Date: July 6, 2016
To: Timpte Branch and Dealer Parts and Service Personnel
From: Product Engineering
Parts & Service Bulletin #33
Reference: 1 ¾" HGC Hopper Knock Rail Standardization

Timpte Product Engineering has determined that the knock rail arrangements for all Timpte 1 ¾" HGC Hoppers will be standardized as follows:

KNOCKRAIL LOCATIONS 1-3/4" HIGHER G.C.
40'/42'-2"/43'/48'+

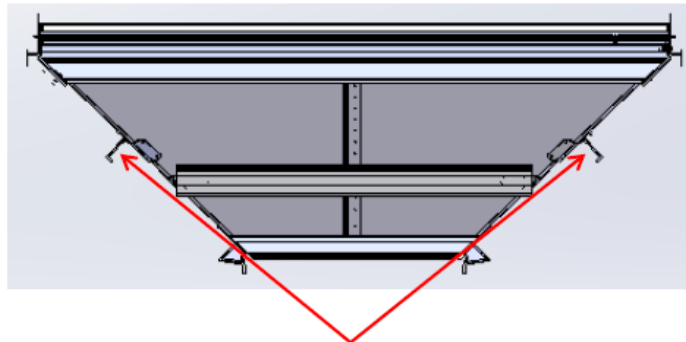
- RDSD and CBSD Upper Position Knock Rails for all 1 ¾" HGC Hoppers
- End and Center Panel Lower Position Knock Rails for all 1 ¾" HGC Hoppers
- We currently offer the following 1 ¾" HGC Hopper Options:
 - #00328-4022, 40' 102W 72H
 - #00328-4024, 40' 102W 84H
 - #00328-4222, 42' 2 102W 72H
 - #00328-4224, 42' 2 102W 84H
 - #00328-4228, 42' 2 102W 78H
 - #00328-4324, 43' 102W 84H
 - #00328-4328, 43' 102W 78H
 - #00328-5020, 50' 102W 90H
 - #00328-5024, 50' 102W 84H
- Additional knock rails can be added to these 1 ¾" Hoppers using existing knock rail options:
 - 00359, knock rail lower position RDSD formed split tub
 - 00360, knock rail lower position CBSD formed split tub
 - 00361-//2/, knock rail upper position End Slopes formed split tub 102W
 - 00363-//2/, knock rail upper position Center Slopes formed split tub 102W

LOWER POSITION ON ENDS & CENTER

UPPER POSITION ON RDSD & CBSD
